DeKalb County Government

File #: 2020-0320

PETITION NO: N8. CZ-20-1243853 (2020-0320)

STAFF ANALYSIS

2020 Site Plan

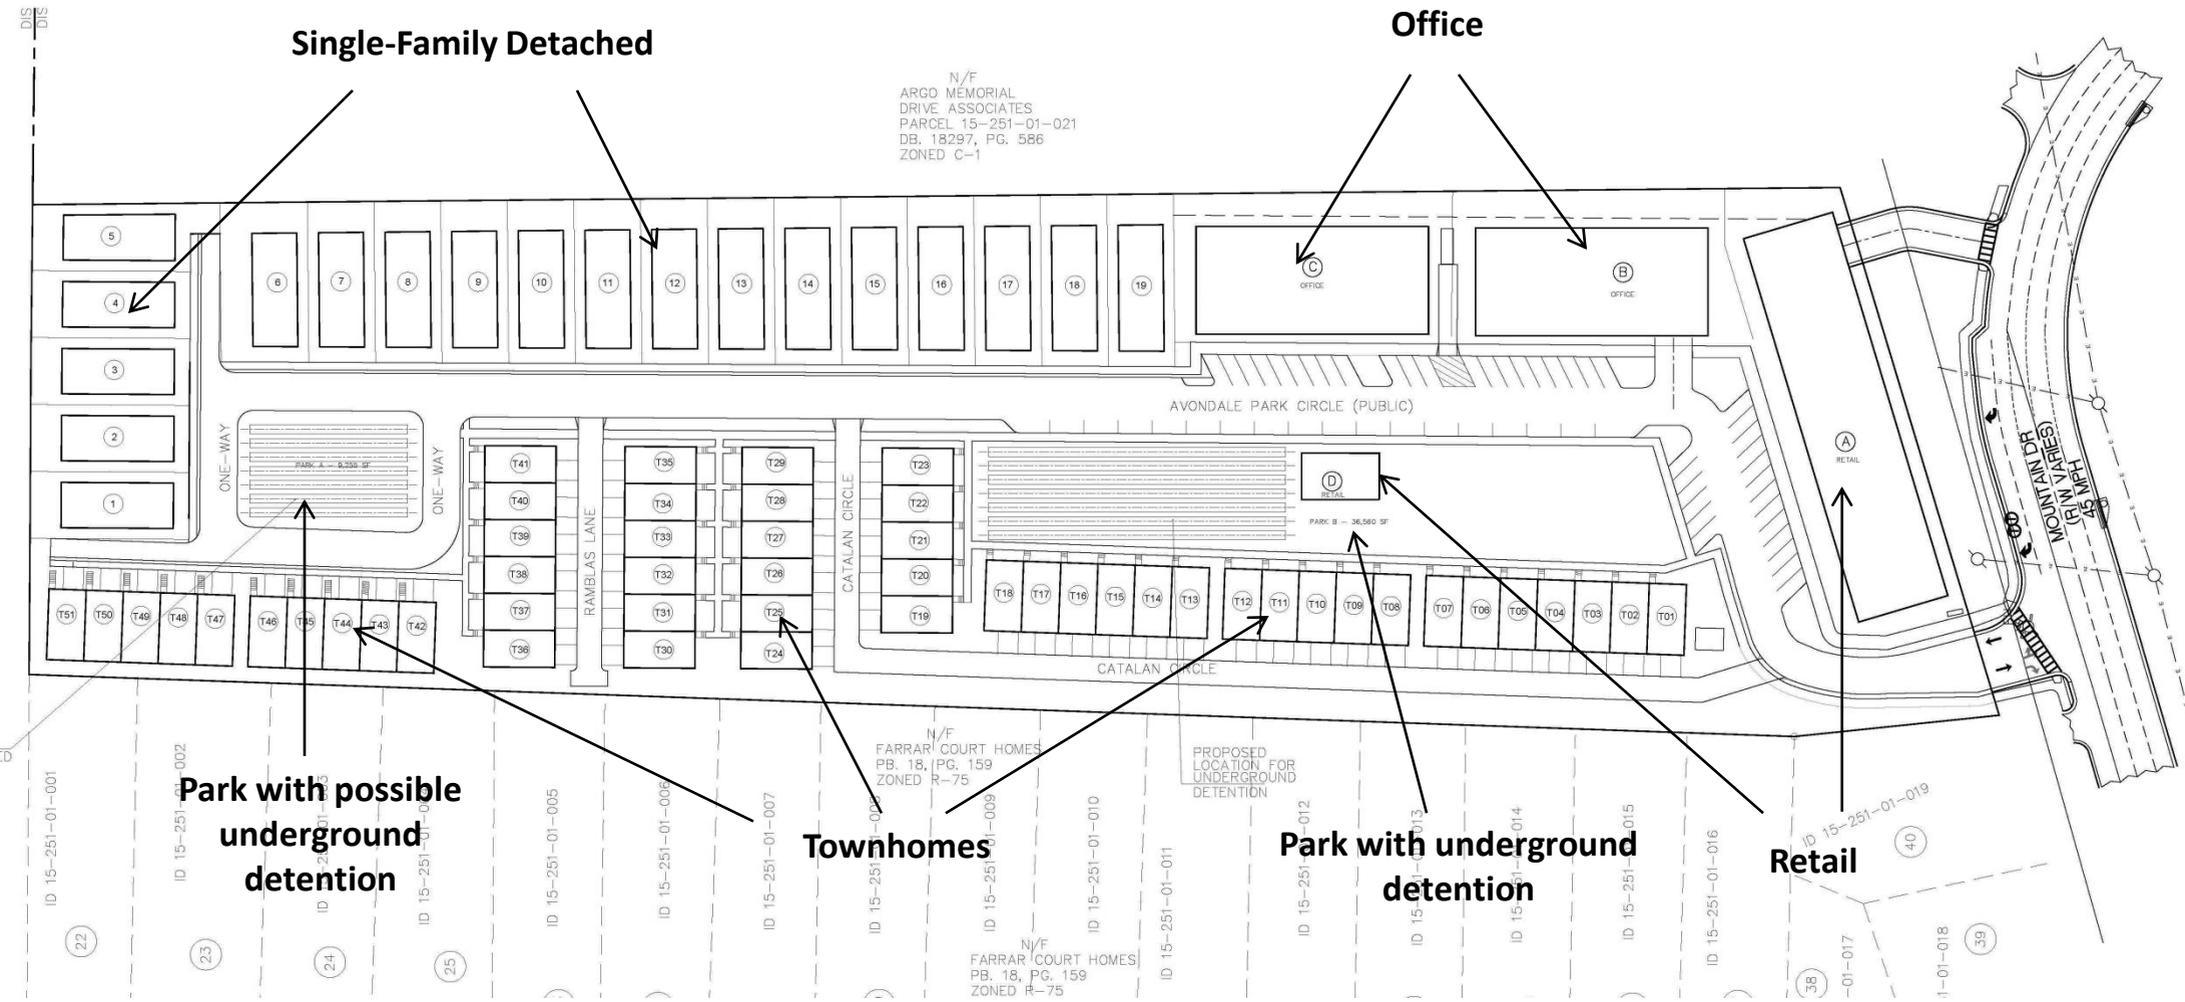
The townhomes are proposed to be a maximum of 35 feet high. The rear yards of several townhouse units along the western property line are located closer to the property line than the minimum of 50 feet required for the transitional buffer, and need to be screened with a combination evergreen landscape screen and opaque wall. In addition, because the rear yards of the single-family homes on the eastern side of the site will overlook the County Tax Commissioner’s office and parking lot, they should be screened to provide privacy to the residents of the homes.

Staff has advised the developer that if any of the buildings are more than 30 feet high, the International Fire Code requires adjoining streets to have a paved width of at least 26 feet. Because some of the streets and alleys are 16 and 24 feet wide, some modifications to the site plan might be necessary when the plan is reviewed by Fire Department staff for the land development permit.

Staff has recommended that the townhomes along the west property line and the single-family homes along the east property line be screened with a combination evergreen screen and solid fence. If developed in accordance with these recommendations, the proposal is not expected to adversely affect the use or usability of the single-family properties in the adjoining Farrar Court single-family subdivision, even with the reduced buffer depth next to Units T42 – T51. The proposed townhomes at the north end of Avondale Park are not expected to negatively impact the multifamily development to the north, as the closest multifamily building on the adjoining property to the north is approximately 65 feet to the north property line of the Avondale Park site.

1. The project site shall be developed in general conformity with the location of streets, land uses and buildings as shown on the site plan “Proposed Development at Avondale Park”, prepared by Proterra Development LLC, dated February 13, 2020. A buffer with a depth of 10 to 20 feet shall be provided between the proposed alley (“Catalan Circle”) of the proposed townhomes and the western property line (abutting the Farrar Court single-family subdivision) as shown on the aforementioned site plan. Existing trees within the transitional buffer shall be preserved and supplemented with new trees to form an effective visual screen as approved by the County Arborist. Invasive species such as bamboo may be removed from the buffer and additional plantings can be added to form a visual screen. Where invasive species are removed from the buffer, special consideration shall be given to prevent erosion and sedimentation during construction. A screen shall be installed along the entire length of the west property line and at the rear property lines of the single-family homes along the east property line, which shall consist of 1) an opaque fence with the finished side facing outwards and with a height of a minimum of six feet and 2) sufficient numbers of the following trees to provide a solid screen at maturity: arbor vitae, cryptomeria, or giant arbor vitae. The latter shall be added to existing trees to
